# Certificate of Appropriateness

2908 W. MC KINLEY BL. Cold Spring Park HD  
 Complete rehabilitation of house with reconstruction of front and rear porches.

6/15/2020  
 PTS 114955 COA: rehab  
 ID

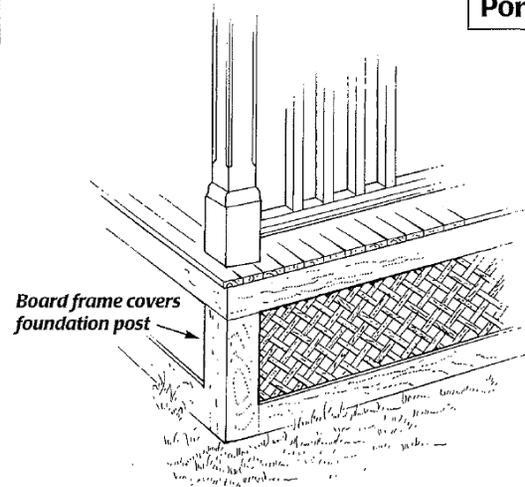
Timberline Natural Shadow Weathered Wood Algae Resistant Architectural Shingles Email on 6/15/2020 changed roofing proposal to this material. Approved by staff.

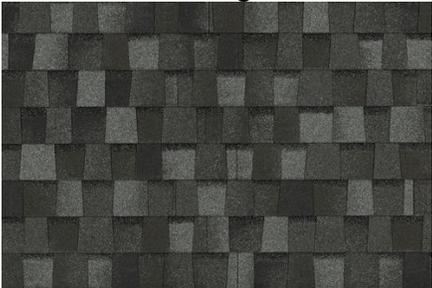
Rear porch skirting will be constructed with a frame, per *Living With History*.

Material: 1 x 6 x 6' Cedar Dog Ear Fence Picket

**SOUTH ELEVATION**  
SCALE: 1/2"=1'-0" PROPOSED

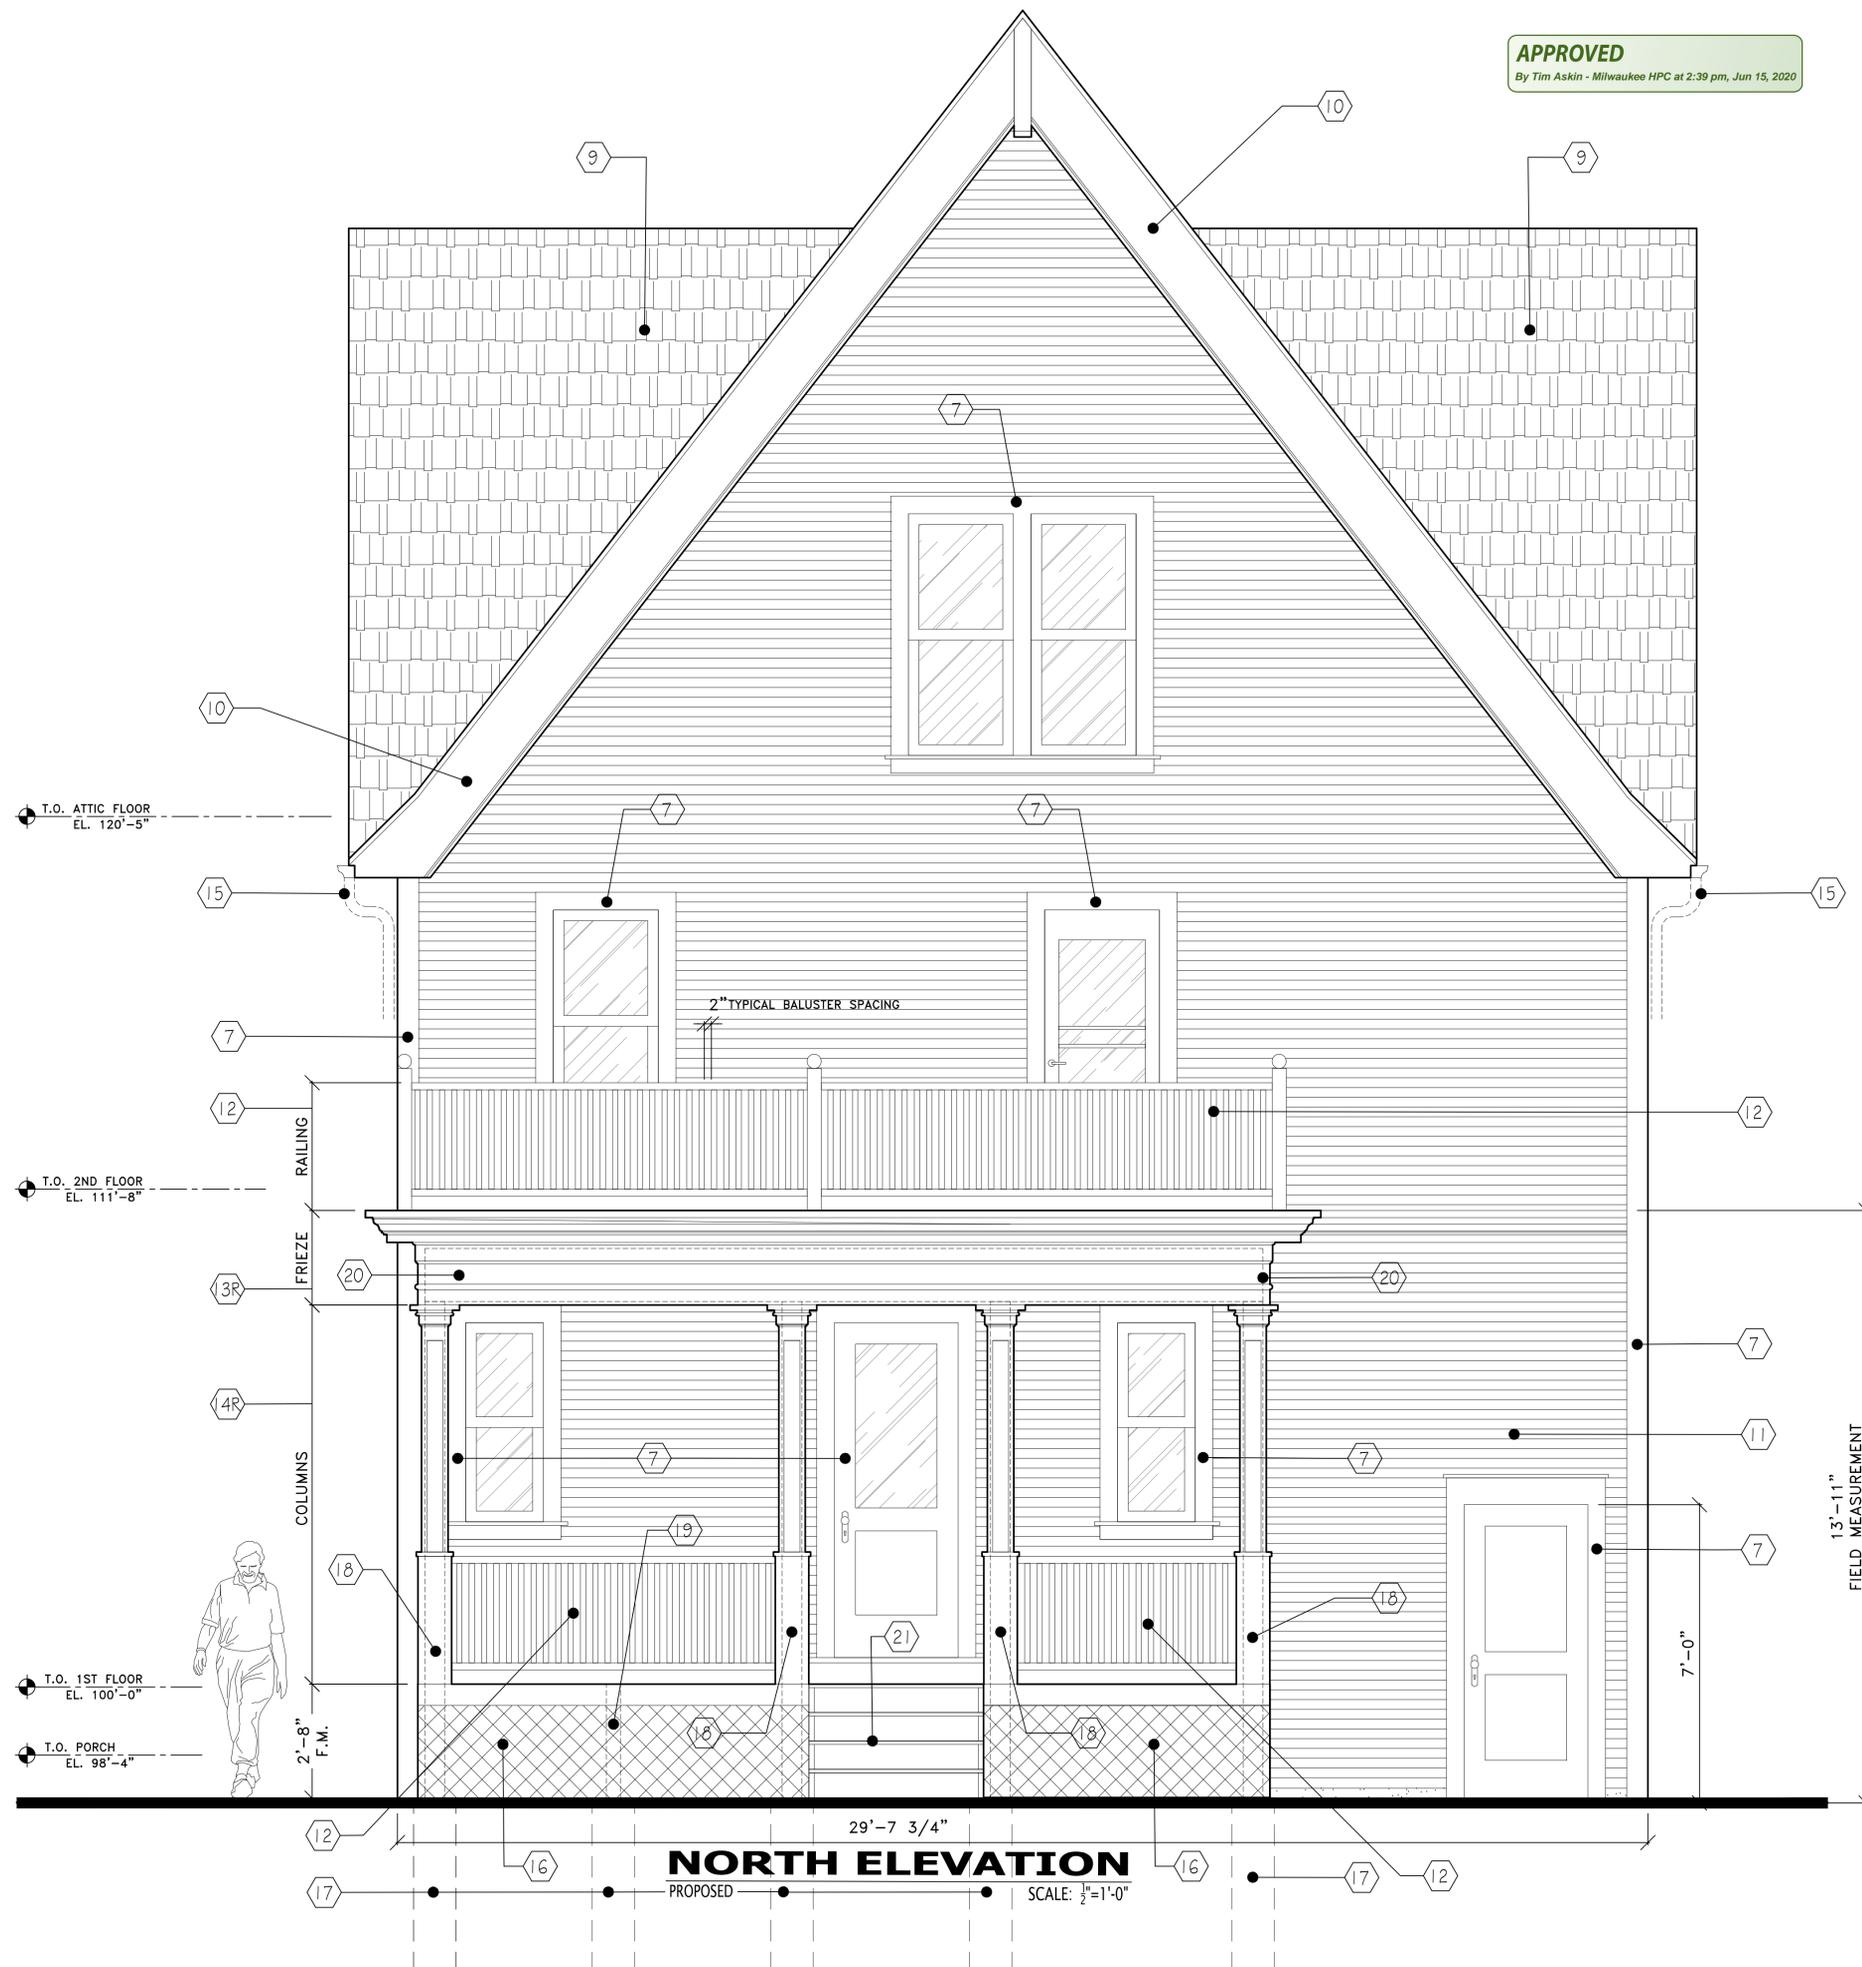
**APPROVED**  
By Tim Askin - Milwaukee HPC at 2:39 pm, Jun 15, 2020
